S.S. PAPADOPULOS & ASSOCIATES, INC.
ENVIRONMENTAL & WATER-RESOURCE CONSULTANTS

December 16, 2020

Subject: Initial review comments on the hydrologic and hydrogeologic analyses for the impact assessment of the proposed Burlington Quarry Extension

Figure 5.12: Water levels recorded in Monitoring Well OW03-14 (175 m to 40 m from Quarry face).

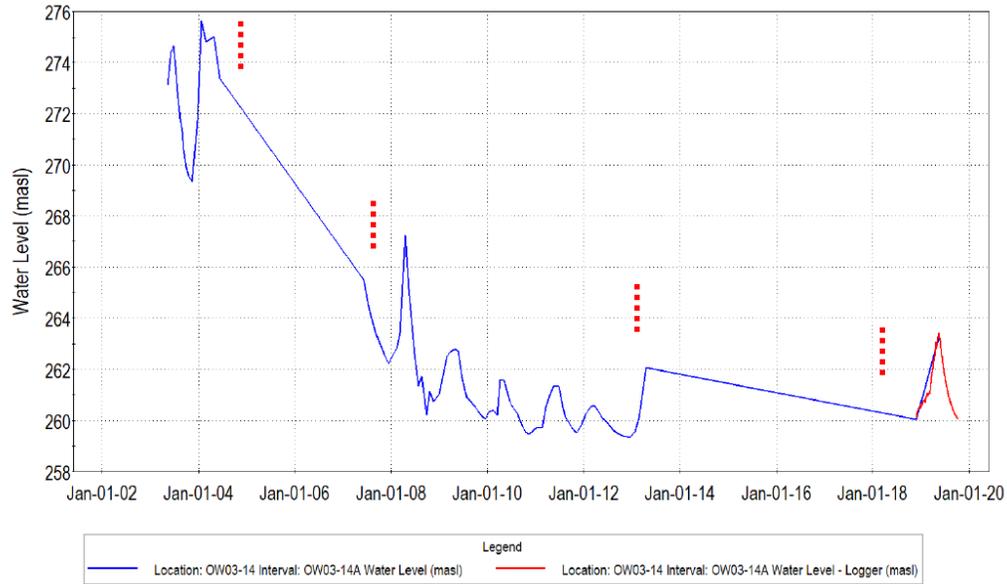
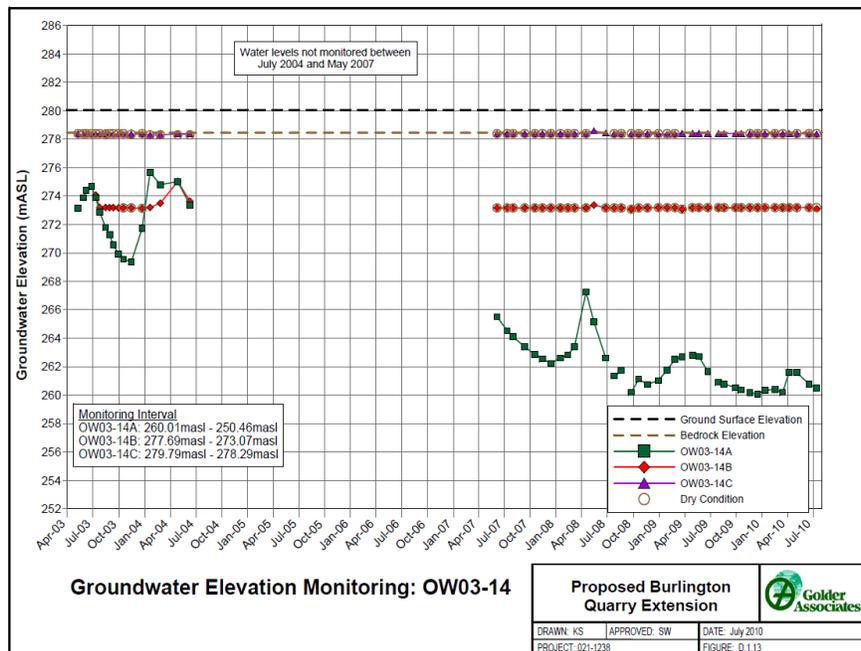
3. Figures 5.11, 5.12, 19.6, 19.12, 19.15: In our opinion, the connecting of the hydrographs across time long gaps provides a misleading impression. The lines connecting the gaps are in effect speculations regarding what might have happened during the gaps. We have reproduced alternate hydrographs for OW-3-14 to illustrate our objections to the presentation and to illustrate an appropriate approach.

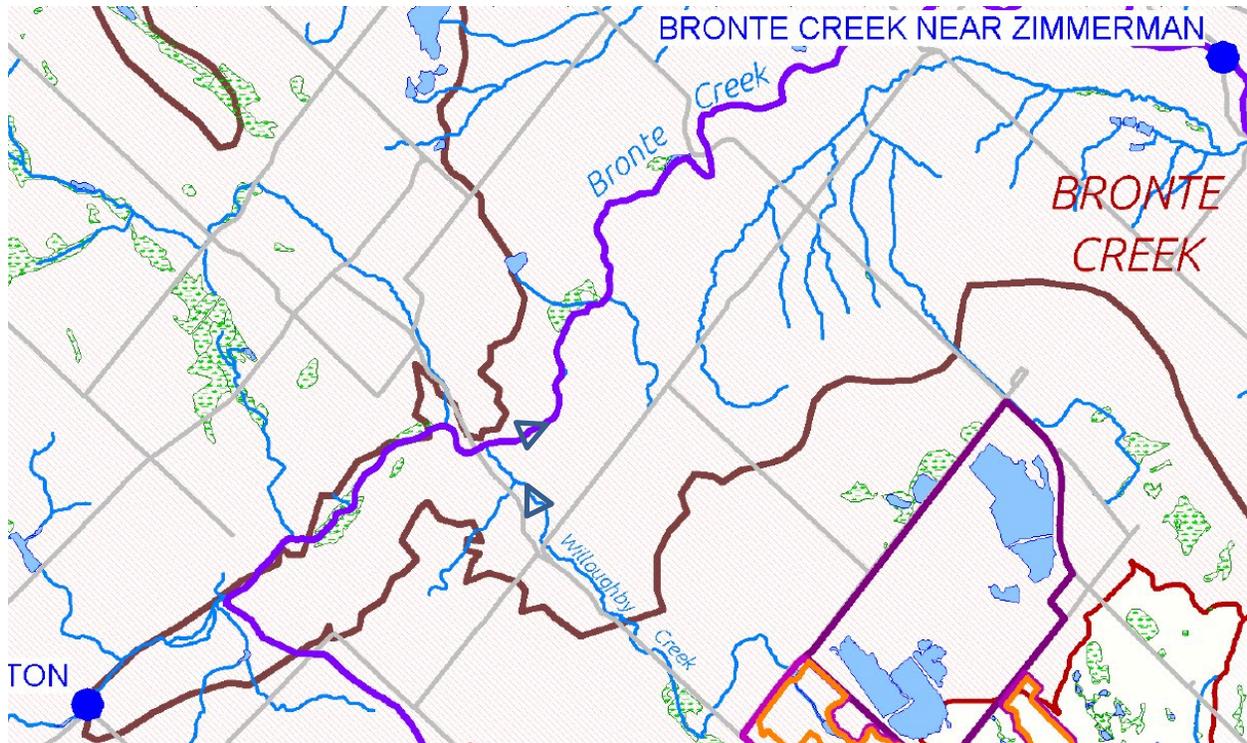
9. Page 86: Referring to Figure 4.10, are we correct in understanding that Willoughby Creek is almost perpendicular to Bronte Creek where it discharges to Bronte Creek?
